9-Speed Transmission Oil Level Control System Changes

9-Speed Transmission Oil Level Control System Changes

TECH LINK

STANDPIPE THERMAL DOOR

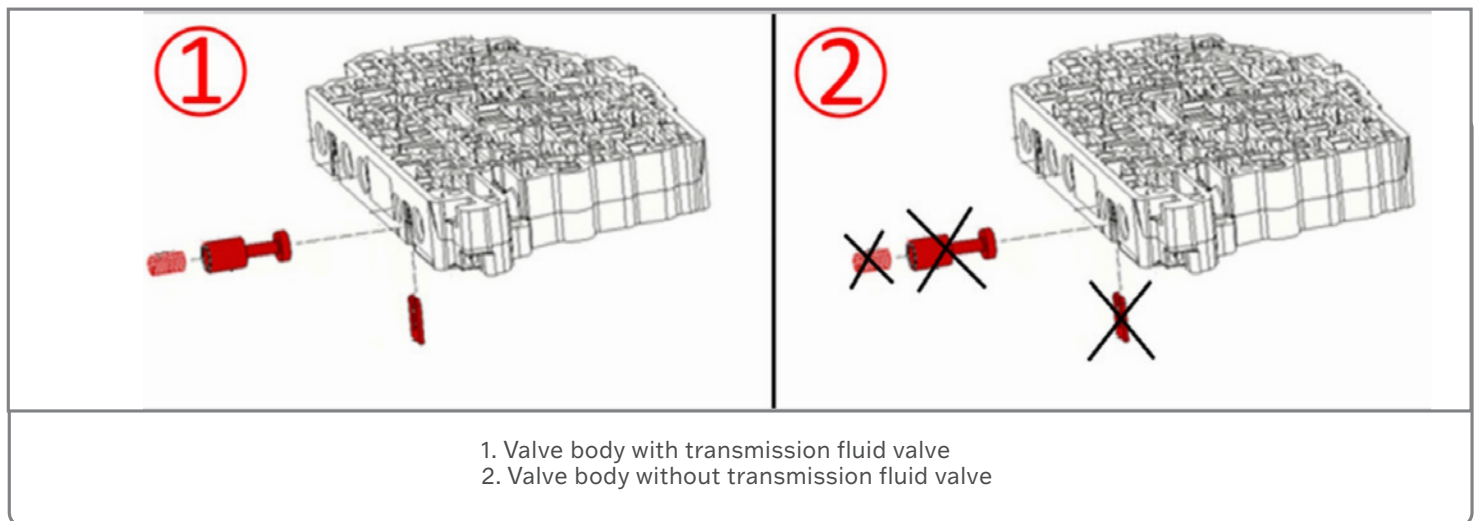
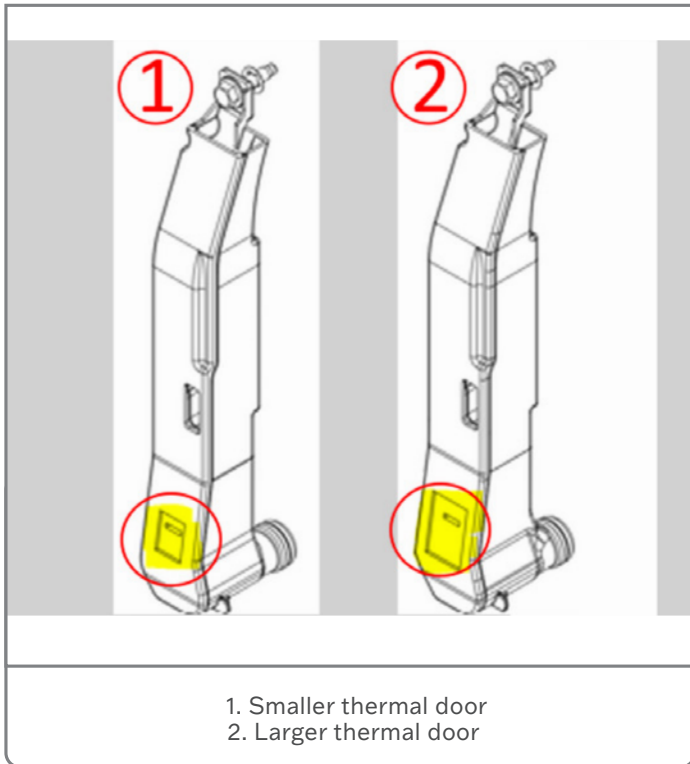
The previous automatic transmission fluid level control valve on the standpipe had a small thermal door. The new style has a larger thermal door on the standpipe, which is necessary for the removal of the OLC components.

The larger thermal door can be used for any model year while the previous smaller thermal door can be used only on 2022 and earlier models.

SPACER PLATE

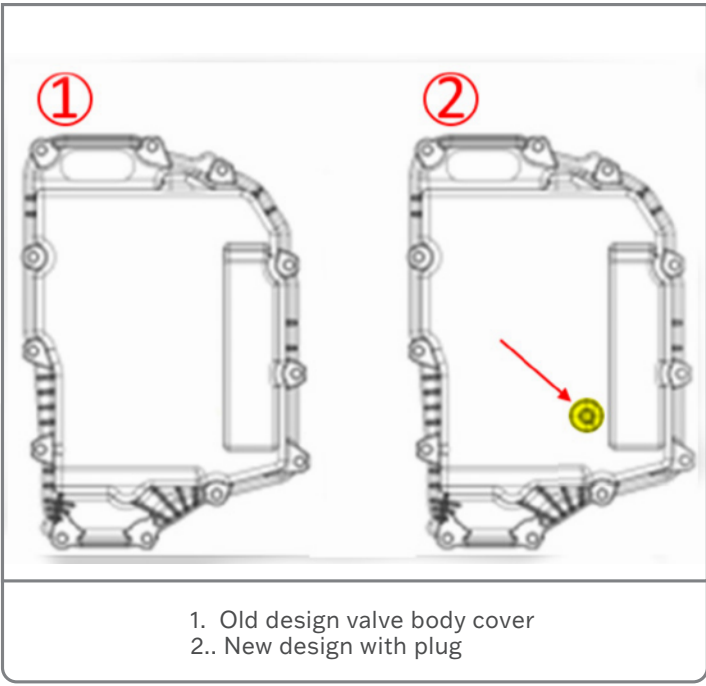
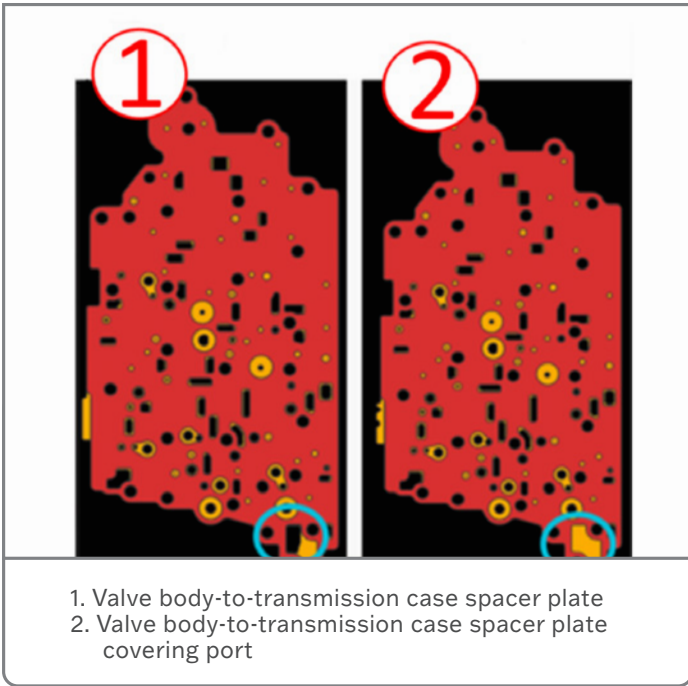
The valve body-to-transmission case spacer plate is now covering over the port.

The solenoid body no longer has the transmission fluid control solenoid and related wiring.

VALVE BODY COVER

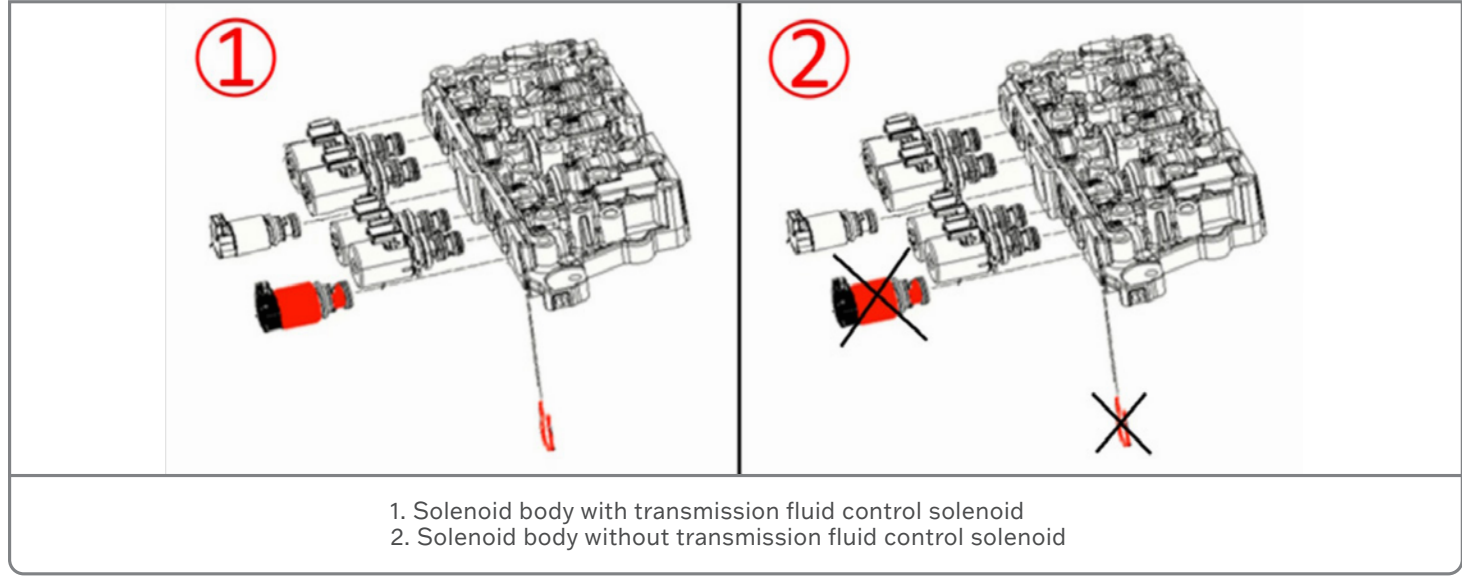
The old and new valve body covers are interchangeable. The new-style valve body cover has a plug that is used during assembly. It should not be removed. The old-style valve body does not have the plug.
